Site Address: 16 Langstone High Street, Havant, PO9 1RY
Proposal: Listed Building Consent for proposed Garden Room extension
with roof terrace above (retaining previous proposals as approved).
Application No: APP/17/00929 Expiry Date: 18/10/2017
Applicant: Mr Oliver
Agent: M Farrer Case Officer: Daphney Haywood
 MF Designs Ltd
Ward: St Faiths

HPS Recommendation: **GRANT LISTED BUILDING CONSENT**

Proposed South (Street Elevation)

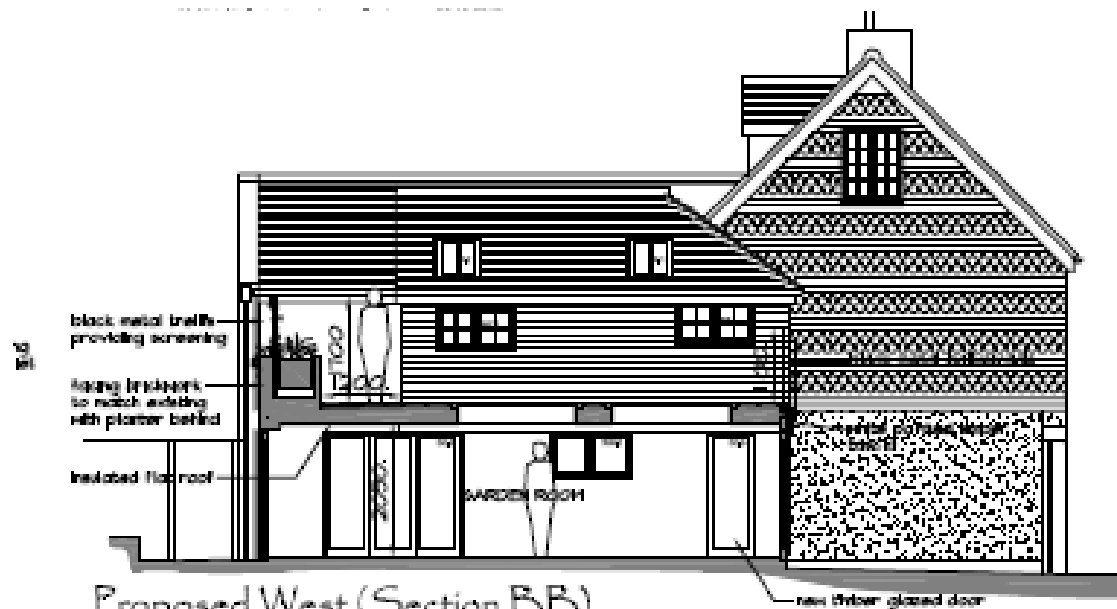
The manner in which the building is viewed means that it is mainly the upper floor that is seen. On reflection I feel the glass balustrade needs amending. Looking at the drawn up plans it does jar with the existing character of the property and the surrounding area. I would therefore recommend the scheme is amended to either remove the balustrading altogether or a more suitable material is used like traditional black iron railings.

This relates to the size of the bathroom window opening at first floor, facing the street. This opening is much larger than other window openings facing the street. Being as it is to serve a bathroom and that the existing house projecting forward of that window would limit views of the harbour, the Conservancy still questions why the opening needs to be that big and being a bathroom why it needs to function as a Juliet balcony?

This window is not annotated as being frosted and whilst the applicant may have no qualms 'appearing before the unsuspecting public walking in the High Street or along the foreshore, modesty and societal 'laws' of propriety would suggest a planning condition to at least require obscure and fixed glazing to that window, ought to at least be considered by the council!

Notwithstanding similar having been approved under APP/15/00853 and that the Conservancy's objection was misunderstood in the Officer report at that time, a smaller window, central to the width of the wall it sits in would seem more appropriate, perhaps centred on the ridge of the roof over it.

Officer comment: The balustrading has been amended to black iron railings.
